Date: January 12, 2023
To: Planning Board
From: Terrence Dolan, Town Planner
Subject: SP2022-09 371 Elm Street, LLC, for the property located at Tax Map 16, Lot 1, 371 Elm Street. Minor Site Plan for a change of use from a motel to a multi-family apartment building and related site improvements on the subject property located in the Integrated Commercial Industrial district and West Elm Overlay. (Continued from 12/20/22)

RE: Minor Site Plan
Map 16 Lot 1, 371 Elm Street

MINOR SITE PLAN
TAX MAP 16 LOT 1 - 371 ELM STREET
MILFORD, NEW HAMPSHIRE

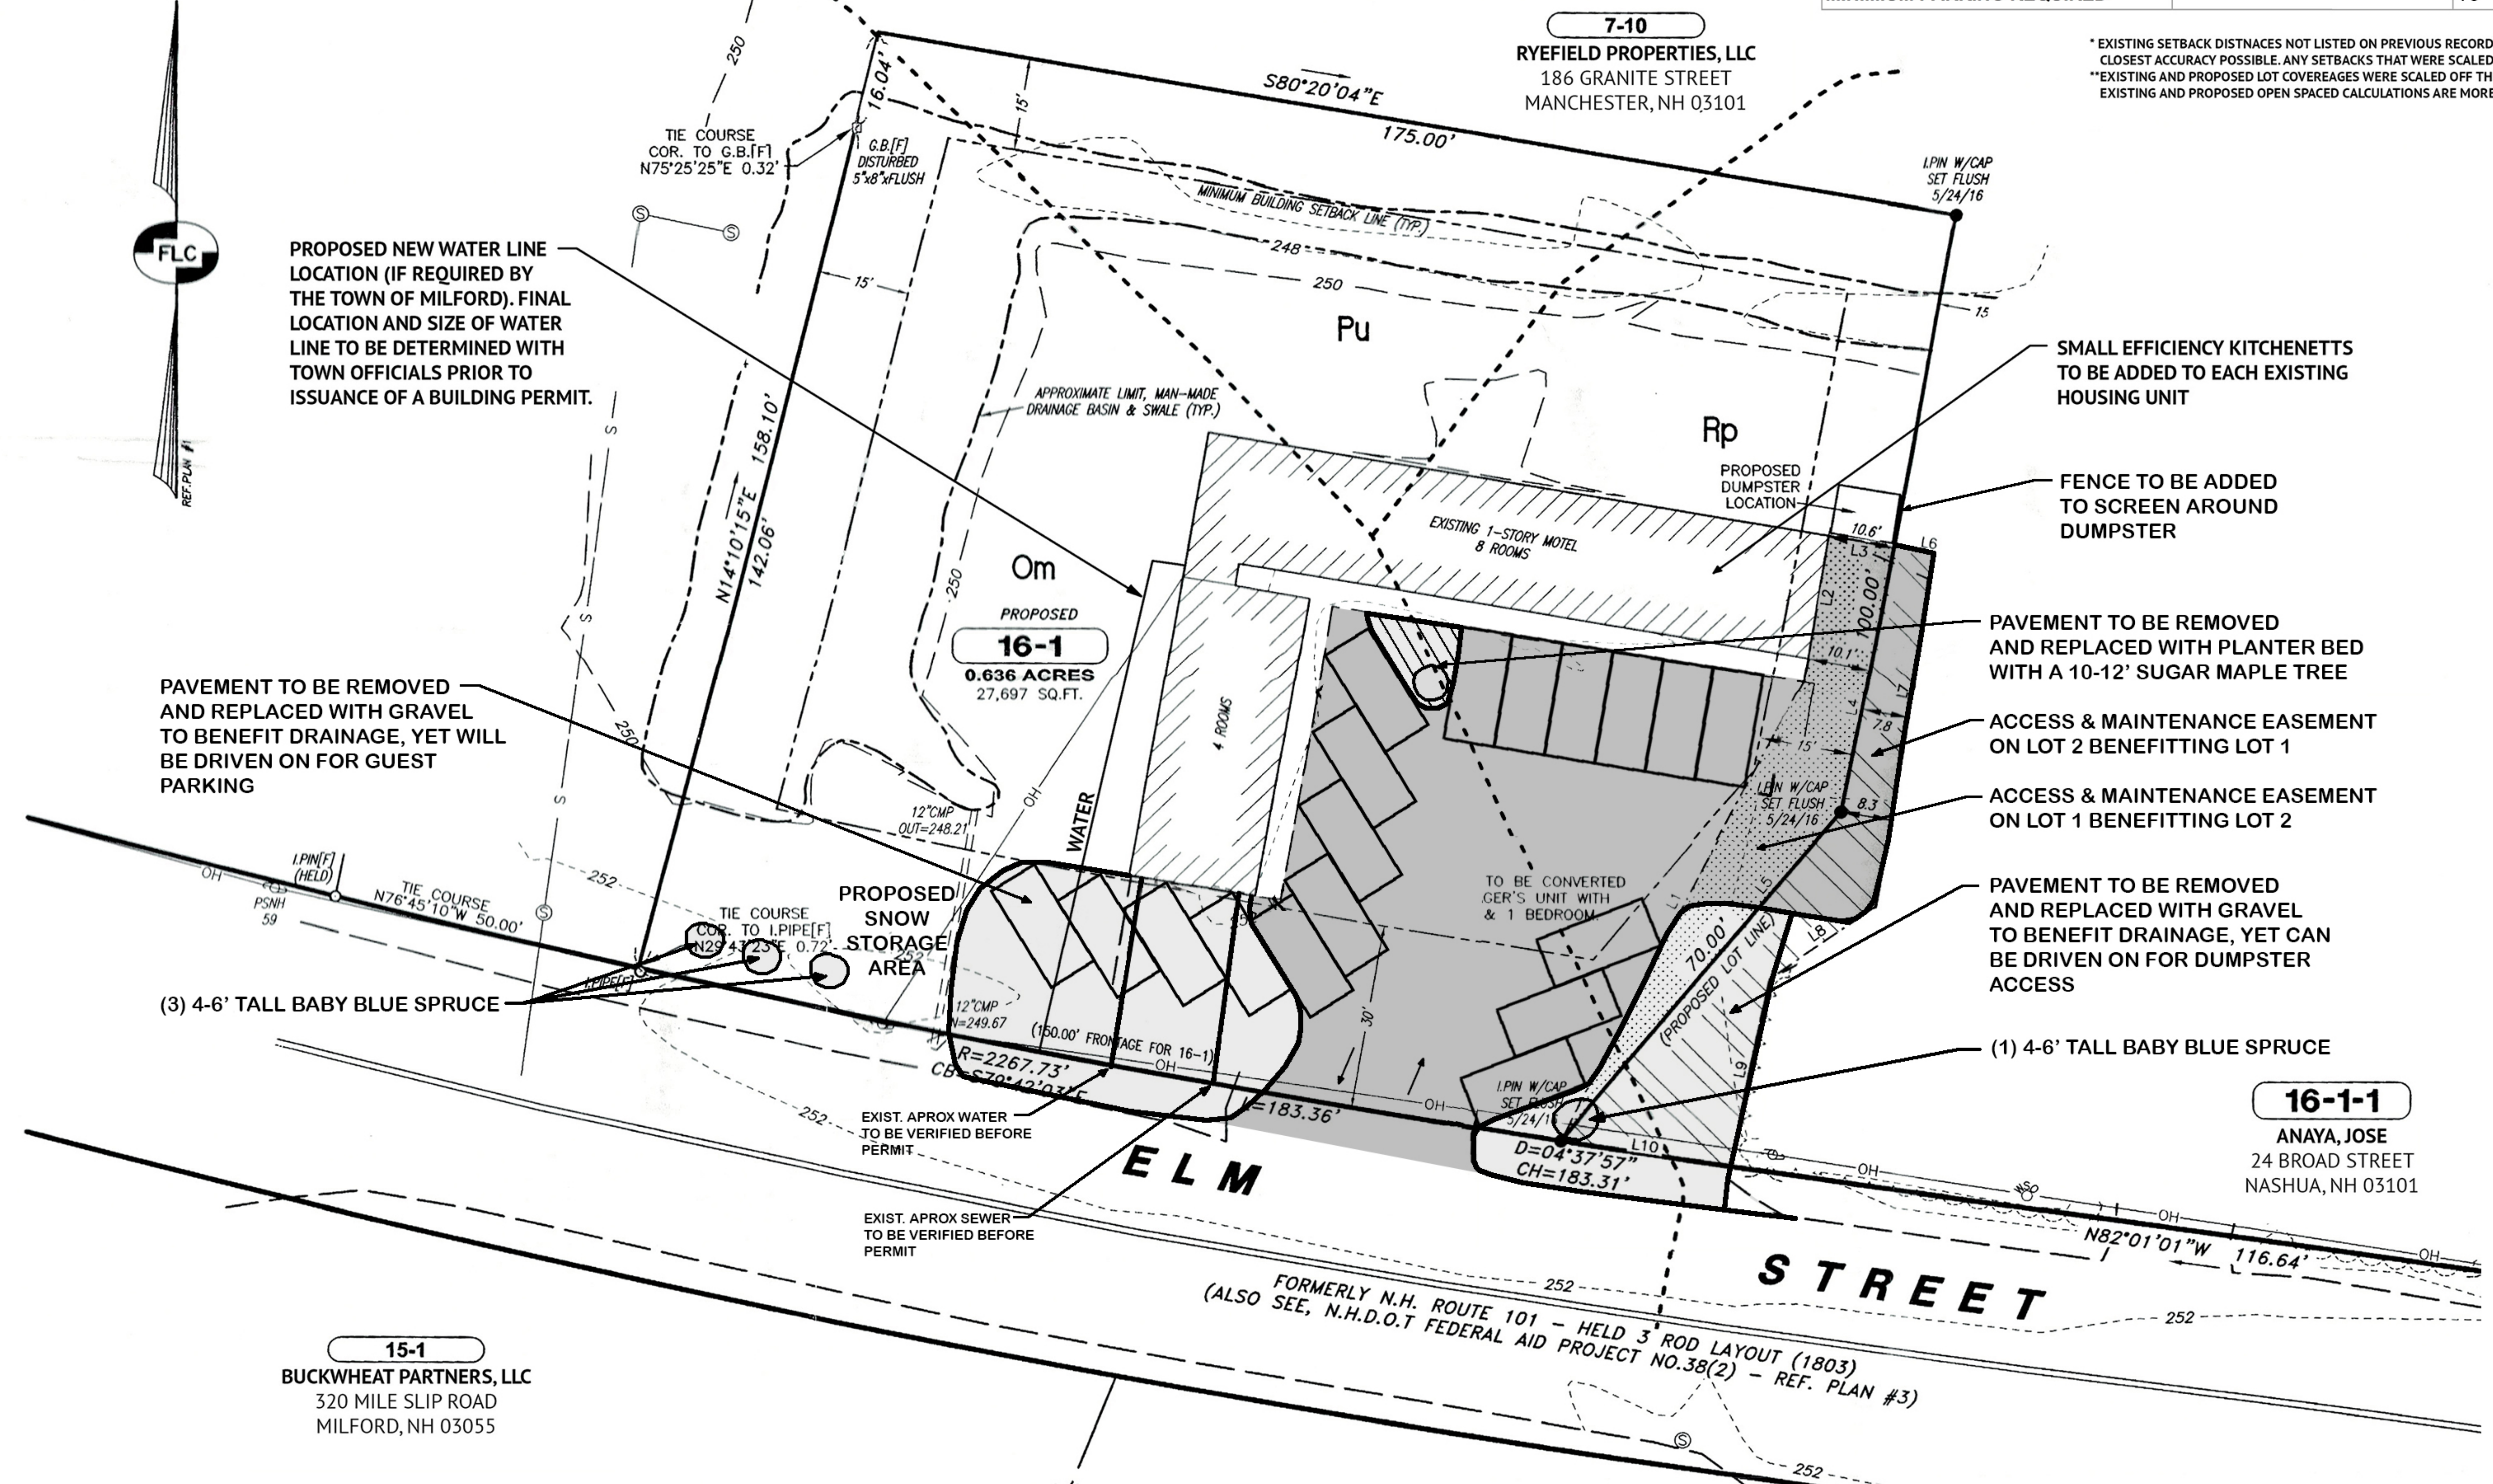
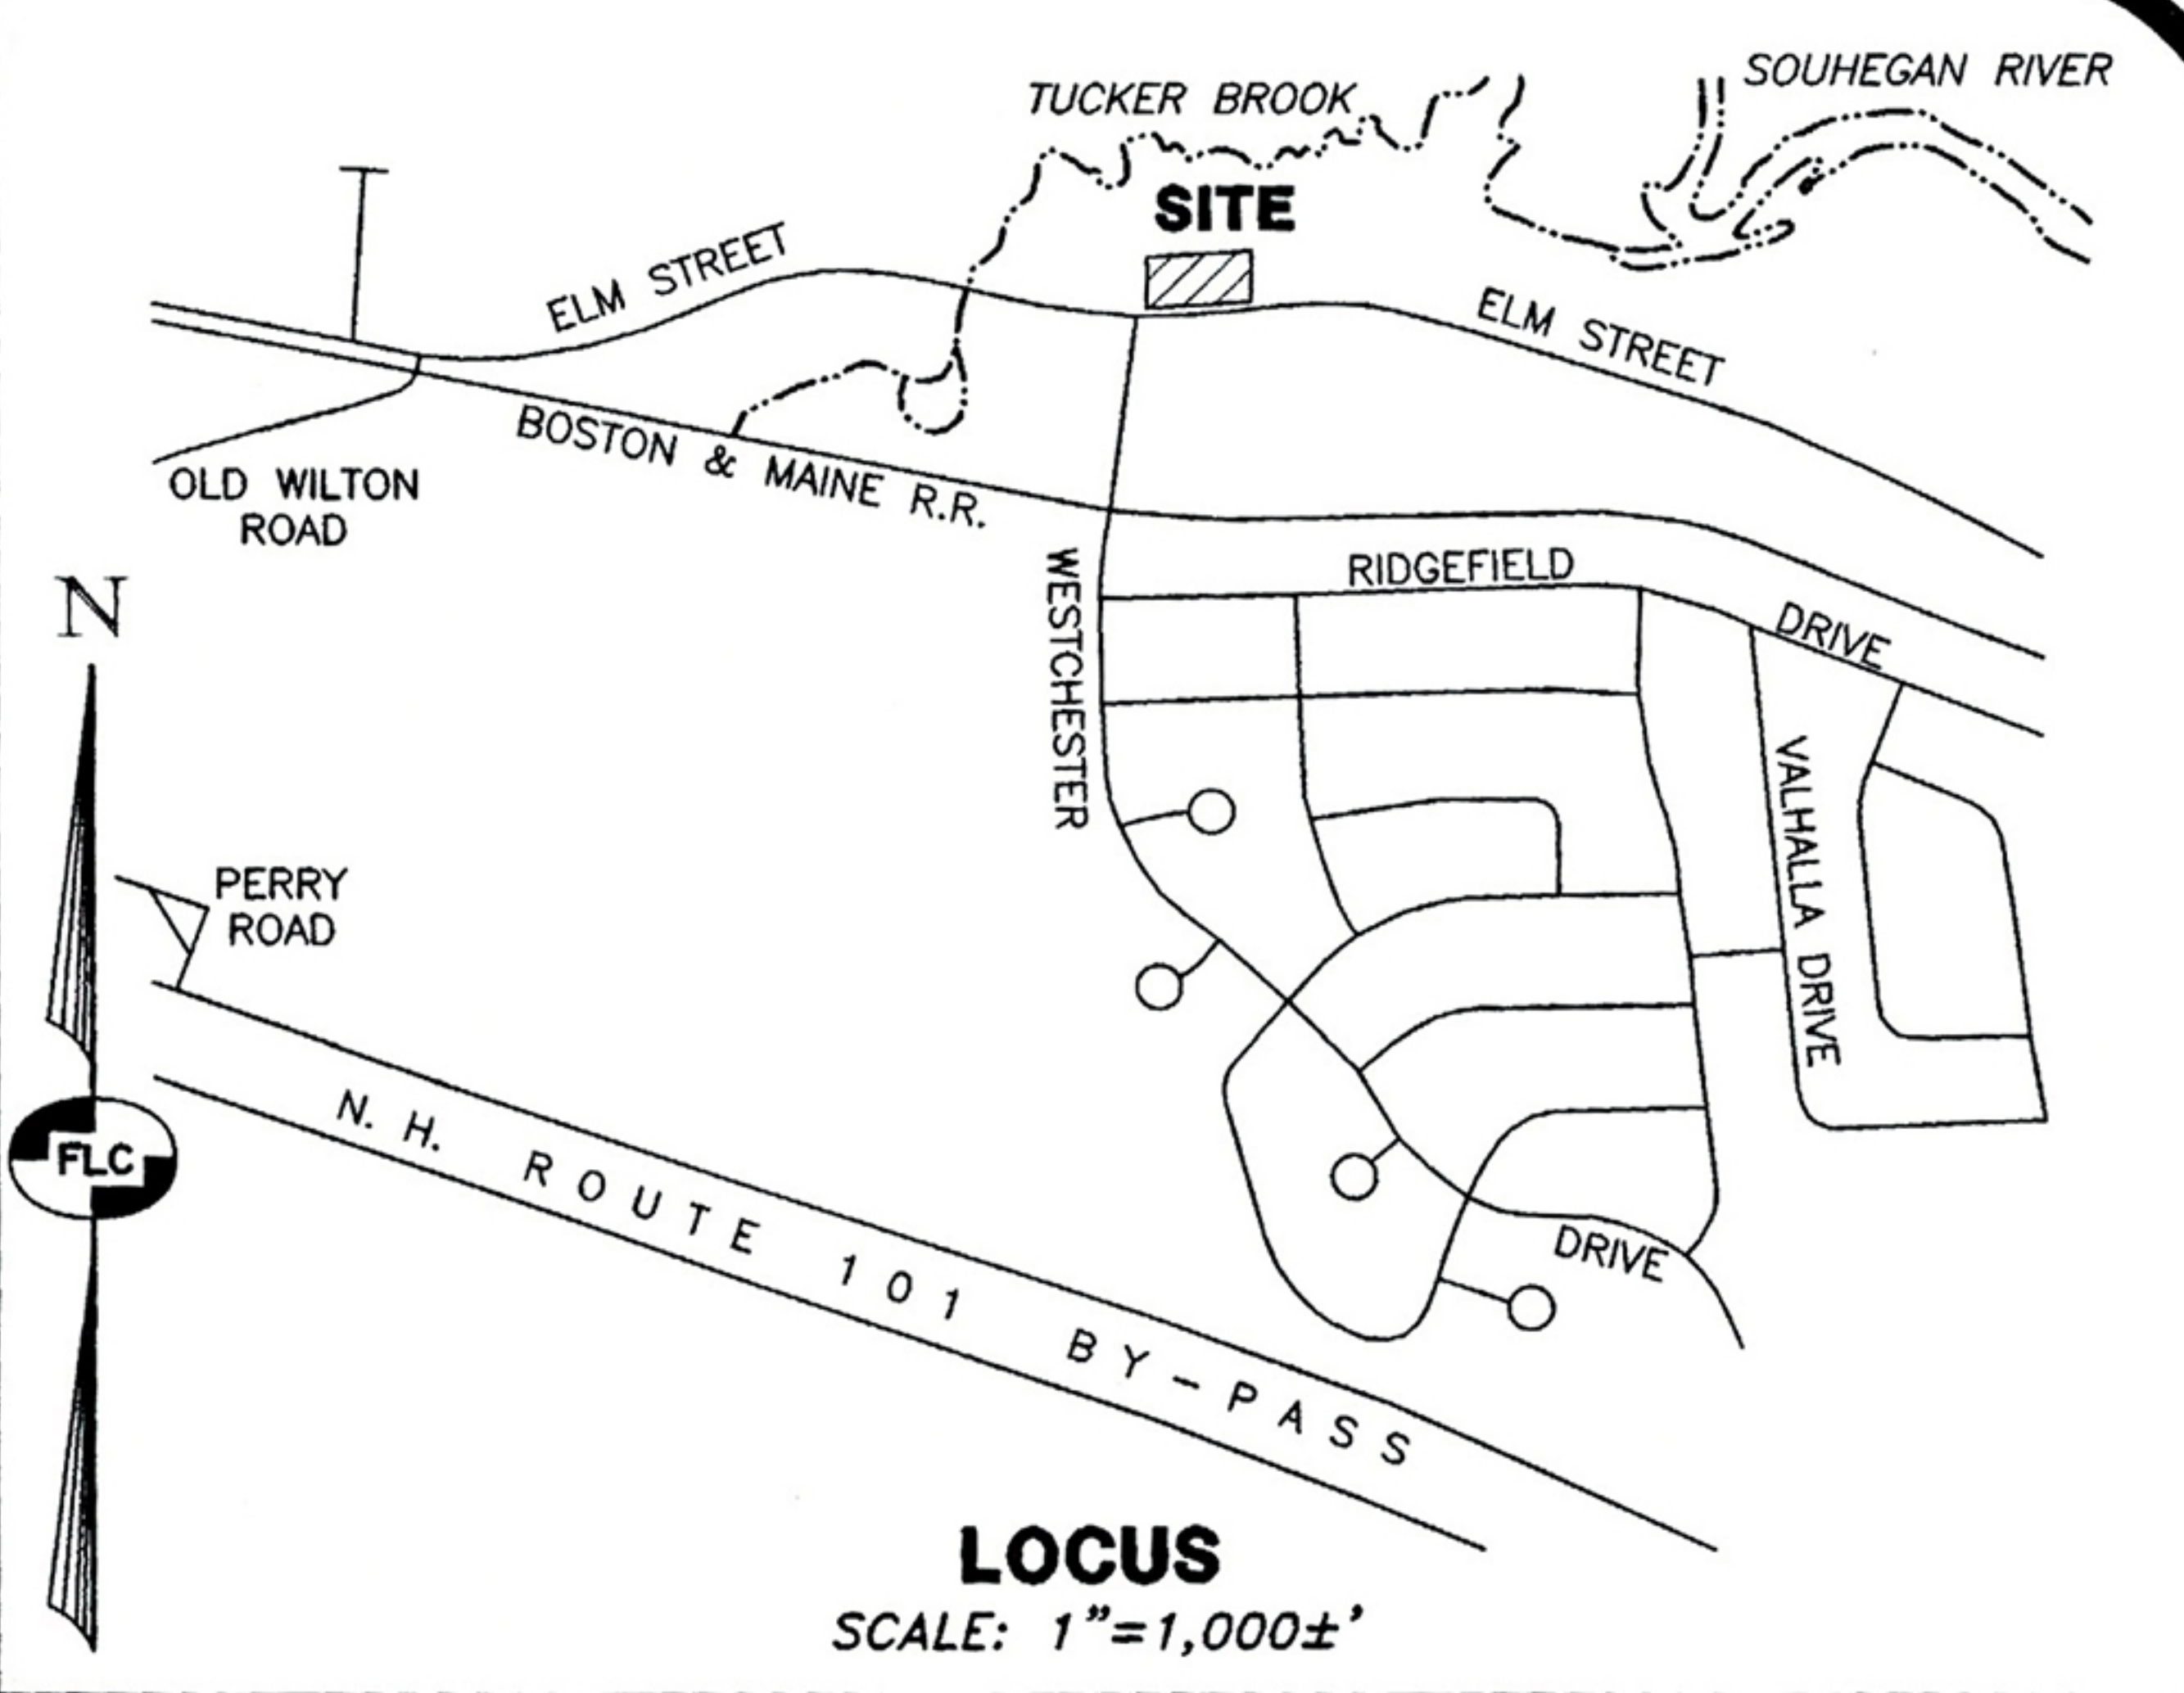
2. Sheet 1. Revise the numbering of the listed Notes section to be sequential.
3. Sheet 1. The orientation and location of the proposed parking spaces result in potential internal conflict for the tenants of the apartments. Staff recommends that the Planning Board direct staff to work with applicant to assist in the layout and design of the **12** existing parking spaces. If the Board supports the waiver request allowing the 12 total spaces, staff recommends that as part of the lease agreement for each unit, a condition specifically stating that one parking space is assigned per unit. In addition, if the number of vehicles exceed 12 on the site on a consistent basis, the property owner shall be required to submit an amended site plan to the Planning Board seeking additional parking.

4. Sheet 1. The applicant will be required to submit written approval of the owner the abutting parcel, Tax Map 16, Lot 1-1 to allow the removal of the impervious pavement located between the properties and minor grading.

5. Sheet 1. Staff recommends that the Planning Board direct staff to work with the applicant to ensure said minor improvements and grading manage stormwater effectively on the properties.

6. Sheet 1. Revise the plan to include a dumpster pad and related screening detail.

3. **Drainage and Stormwater Management (Dawn Tuomala, Town Engineer)** – See attached 1/13/23 letter.
4. **Parking:** The revised *12-23-22 Site Plan* (see attached) does not facilitate safe vehicular movement throughout the parking lot area-as presently designed with the six (6) additional spaces being adding to the existing 12 parking spaces for a newly proposed total of eighteen (18) parking spaces.

- In Lieu of the proposed six (6) additional spaces, to maintain and ensure safe vehicle maneuverability through the parking lot area, a *maximum* of three (3) additional 90-degree pull-in parking spaces *may* be achieved, abutting the southerly end of the west leg of the residential units.

- The goal of obtaining an *additional 5-6* parking spaces over and above the existing 12 parking spaces (as designed) is highly unlikely to be successfully accomplished. As well, the southwestern-most (existing) parking space warrants deletion in any site re-design.

- In order to facilitate the concept of the three (3) additional parking spaces, **the existing southwestern-most parking space will need to be eliminated, thus leaving eleven (11) original parking spaces.** By designing and adding three additional parking spaces this would yield **a new development total of: 14 Parking Spaces, overall.**

Need to eliminate existing parking space to facilitate addition of ± 3 additional spaces (90°) between so. bldg. end + Elm St ROW line.
